Office Action Summary

10/774,250

DETAILED ACTION

FIG. 6 150

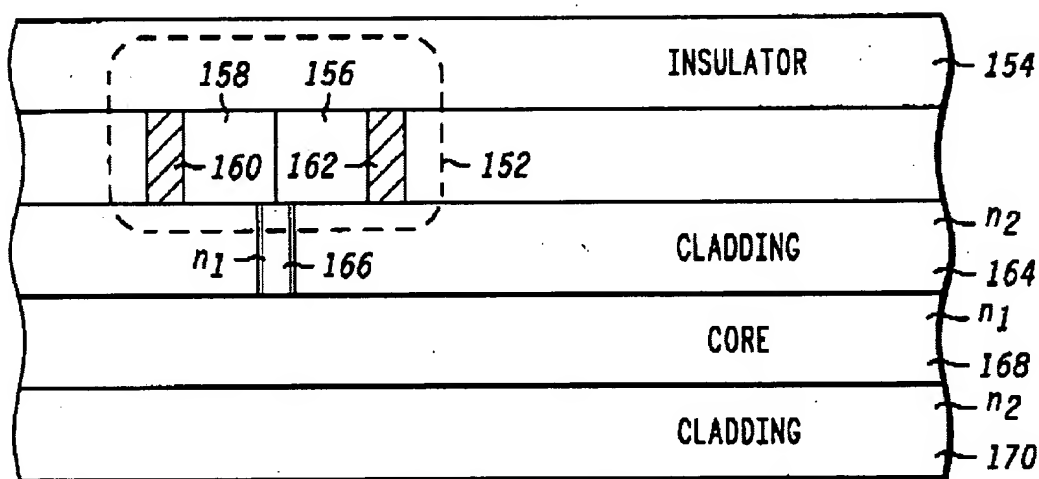
In re claims 1, 2, and 27, the '642 patent discloses a multiple source array (e.g., Figure 6) comprising:

a guided-wave structure 150 in which one or more guided-wave modes are excited during operation, said guided-wave structure 150 including a planar dielectric core 168, a first dielectric cladding layer 164 covering and defining a boundary of a first side of the dielectric core 168, and a second dielectric cladding layer 170 covering a second side of the dielectric core 168 that is opposite from the first side; and

a dielectric-filled guided-wave cavity 166 in the first cladding 164 beginning at said boundary and extending transversely from the dielectric core 168 into the first cladding 164 and forming an aperture through which optical energy that is introduced into the core exits from the core, the cavity causing said optical energy to exit from the core through the aperture (col. 3, lines 41-58). The cavity 166 inherently has one or more transmission modes that during operation couple to the one or more guided-wave modes of the guided-wave structure because the structure of the '642 patent is identical to that of the claims. Although only one cavity 166 is shown in Figure 6, it is clear from Figure 2 of the '642 patent that an array of such cavities can also be used. See columns 1-3 for further details. Figure 6 of the '642 patent is reproduced below.

In re claim 3, the guided-wave structure 150 of the '642 patent inherently generates excited-wave modes in response to receiving a source beam characterized by a wavelength λ_0 because the physical structure of the '642 patent is identical to that of the claim. Furthermore, the cladding layers 164 and 170 inherently have thicknesses such that leakage represents a negligible loss to

In re claim 9, the guided-wave structure 150 can be designed to operate at a many different wavelengths (col. 4, lines 2-10)). The cavity 166 also has a selected width. Therefore, the limitations of claim 9 are considered to be inherently present in the '642 patent because there would exist at least one wavelength λ_0 among the many possible wavelengths that can be used in the '642 patent such that the width of the cavity is on the order of $\lambda_0/2n_f$ wherein n_f is the index of refraction of the dielectric in the cavity.

In re claim 10, the guided wave cavity 166 inherently has a selected width so that there exist transmission modes of the cavities that couple to excited wave modes of the guided wave structure because it has the same claimed structure.

In re claim 12, the guided wave structure 150 can operate at different wavelengths as mentioned in columns 4-5. Furthermore, no specific reference wavelength is given to define the term "sub-wavelength". It can be assumed that the cavities 166 disclosed by the '642 patent are smaller than microwave or radio wavelengths which are on the order of 10^2 meters and greater.

In re claim 13, a source that delivers an optical beam to core 168 is inherently present in the '642 patent because there is light present in the core 168 (col. 3, lines 55-58).

In re claims 24-25, the photo-diode 152 shown by the '642 patent corresponds to the recited compensating layer.
